MBE INVESTMENTS, LLC. SUBDIVISION

Engineering Comments: FINAL PLAT COMMENTS (should be addressed prior to submitting the FINAL PLAT for review and/or signature by the City Engineer):

The preliminary plat illustrates the proposed 2-lot, 2.8± acre subdivision which is located on the West side of I-65 Service Road North, 475'± South of Spring Hill Business Park in Council District 7. The applicant states that the subdivision is served by city water and sanitary sewer systems. The purpose of this application is to resubdivide (1) legal lot of record to create two (2) legal lots.

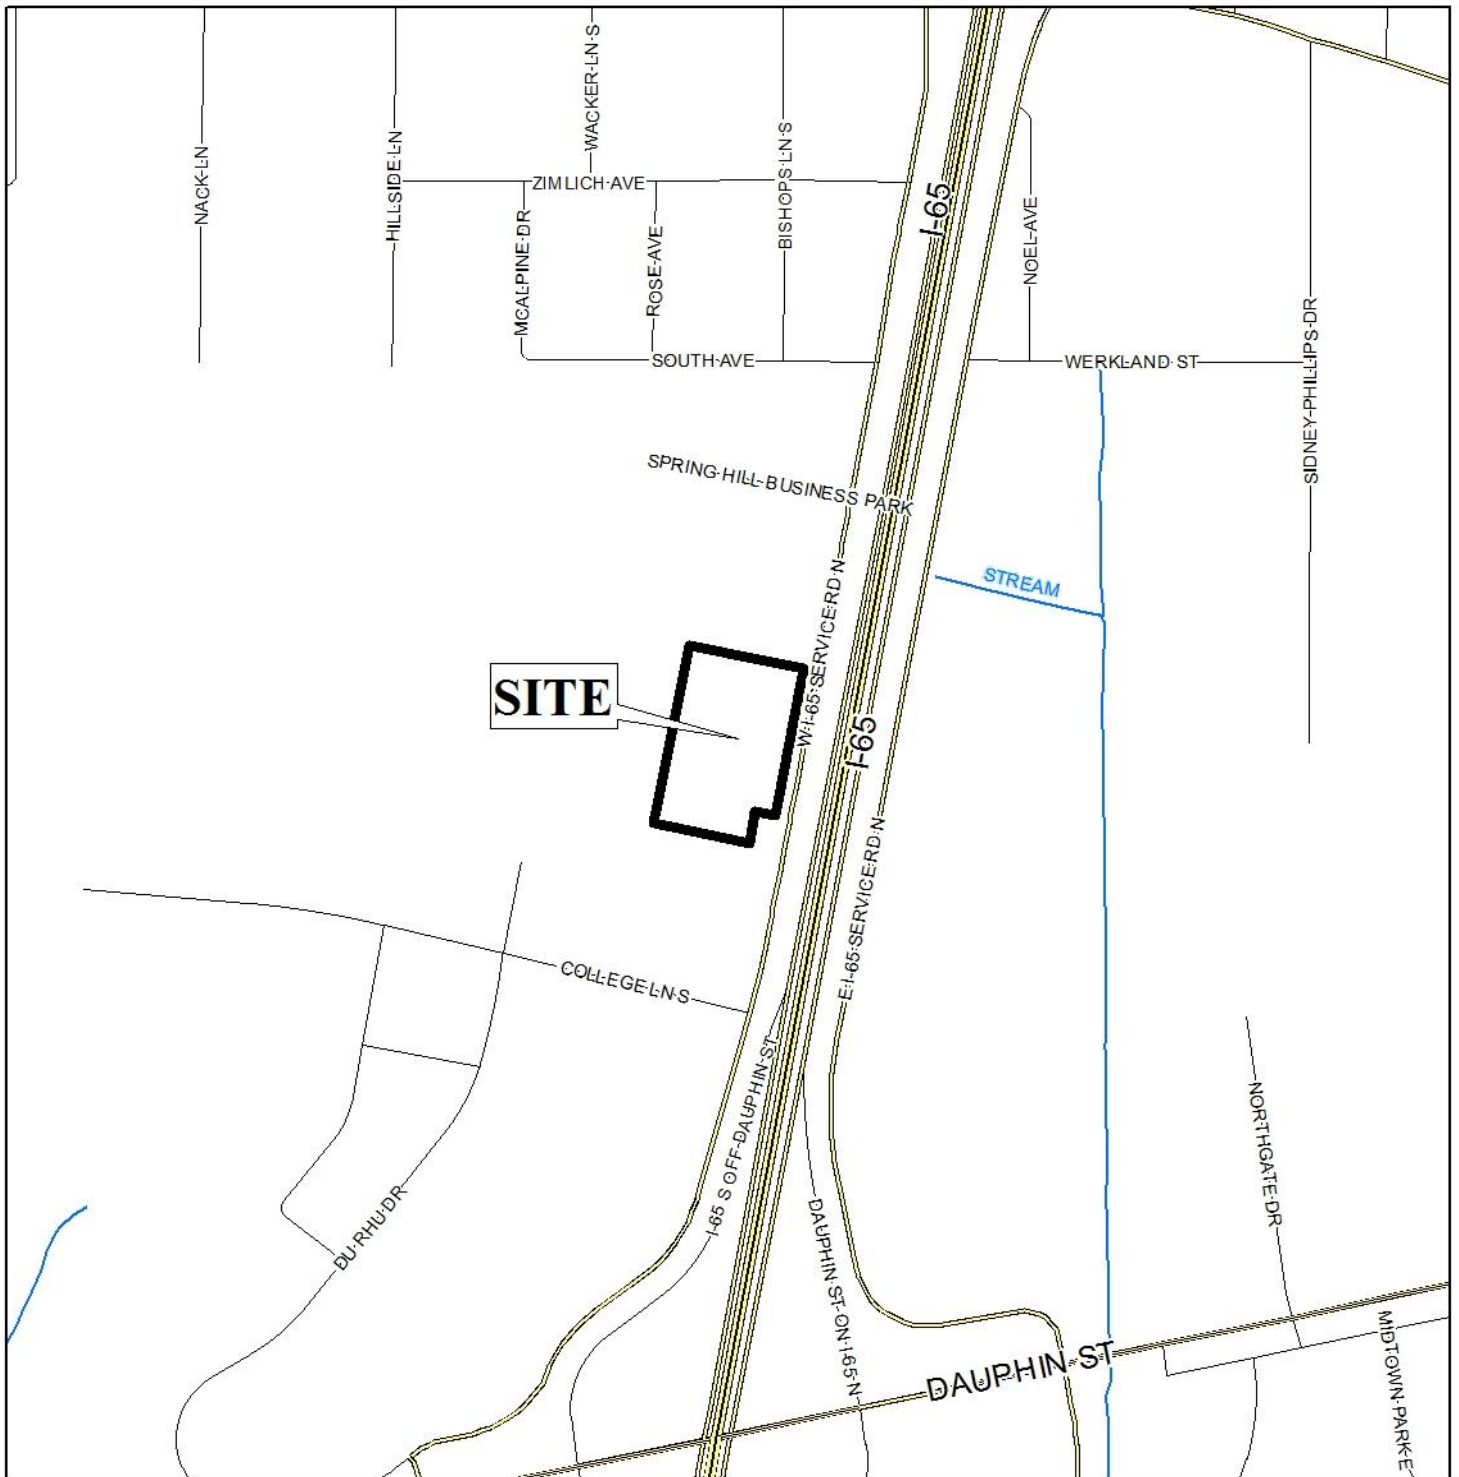
The proposed lot fronts I-65 Service Road North, a major street requiring a 300' right-of-way width. The preliminary plat illustrates a compliant 300' right-of-way width on I-65 Service Road North and, if approved, should be retained on the Final Plat.

A 25-foot minimum building setback is depicted on the preliminary plat for Lot 2A for the southern most 81.46' where the Lot fronts I-65 Service Road North. The minimum building setback is depicted at 69' for the remaining 128.20' of Lot 2A that fronts I-65 Service Road North, as well as Lot 3. If approved, the setbacks should be retained on the Final Plat

The proposed lots exceed the 7,200 square foot minimum lot size requirement for lots served by public water and sanitary sewer systems. The preliminary plat provides the lot size in square feet and acres. If approved, the lot size information should be retained on the Final Plat.

As a means of access management, a note should be placed on the Final Plat stating that West I-65 Service Road North is an ALDOT maintained roadway. Driveway number, size, location and design to be approved by ALDOT and Traffic Engineering and conform to AASHTO standards. Any new on-site parking, including ADA handicap spaces, shall meet the minimum standards as defined in Section 64-6 of the City's Zoning Ordinance.

- 1) Retention of the 300' right-of-way width along I-65 Service Road North;
- 2) Retention of a minimum of a 25' building setback line (or greater) along I-65 Service Road North for Lots 2A and Lot 3;

- 3) Retention of lot size information in both square feet and acres;
- 4) Placement of a note on the Final Plat stating the following Traffic Engineering comments: (*“West I-65 Service Road North is an ALDOT maintained roadway. Driveway number, size, location and design to be approved by ALDOT and Traffic Engineering and conform to AASHTO standards. Any new on-site parking, including ADA handicap spaces, shall meet the minimum standards as defined in Section 64-6 of the City's Zoning Ordinance.”*);
